SUBSURFACE WASTEWATER DISPOSAL SYSTEM APPLICATION

| Street or Road | DEBHAM STREET | | |
| Subdivision, Lot # | (LOT 3-5) | | |

City of Portland, Maine - Building or Use Permit

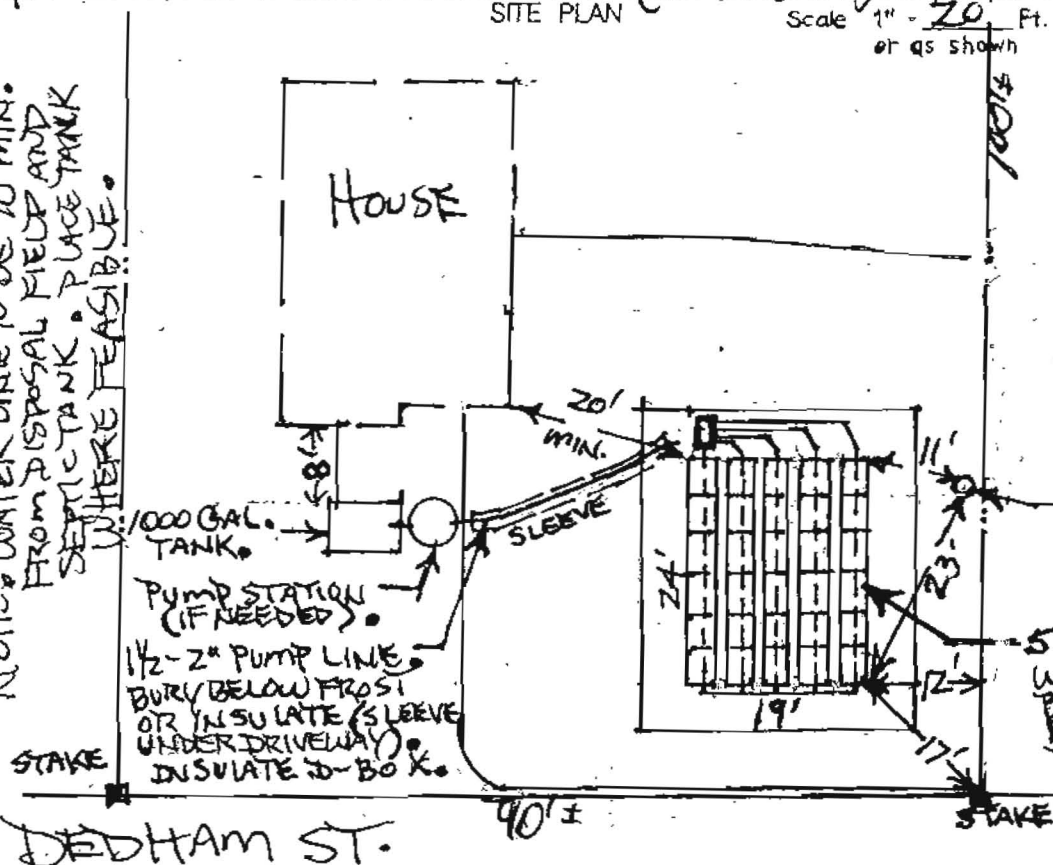
- 1) The pump pipe to the field located under the driveway shall be sleeved and if above 4' shall also be insulated.
- 2) The approved site plan shows a 12' driveway to the left of the disposal field, it jogs right and extends along the side of the building to the rear corner. This site is situated so that a future garage could be built to the right of the principal structure. This septic system is located to the right of the house, it is not designed to handle loading (H-20) requirements for vehicular traffic. The pavement is not approved to extend onto the disposal field or extension. Prior to a future application for garage addition, a review is required by this department for potential implications to this design.
- 3) This approves a reduction in the minimum lot size to 12,000 sf, as allowed in MSWWDR, Chapter 243 Sec. 1000.0.

10/21/2010-jmb: Left vmsg for Mark M. For minimum lot size approval, garage on plan and driveway over the disposal field, as built is mirror of approved house plan, bulkhead addition and survey letter. Also emailed Johann B. @ NECS

10/22/2010-jmb: Mark called back and I returned call, left msg. Spoke with Mark, he will submit all the changes except as built plans, I noted the mirrored as built on the permit notes. He is not adjusting the disposal field location for a future garage. Also left vmsg for Brent L. At state to review the soils for variance per Table 600.2 class 4, and driveway issues.

10/26/2010-jmb: Spoke to Brent L. He confirmed no variance required for the soils and agreed the sleeve is required for the pipe under the driveway.

10/27/2010-jmb: Received revised HHE-200, ok to issue
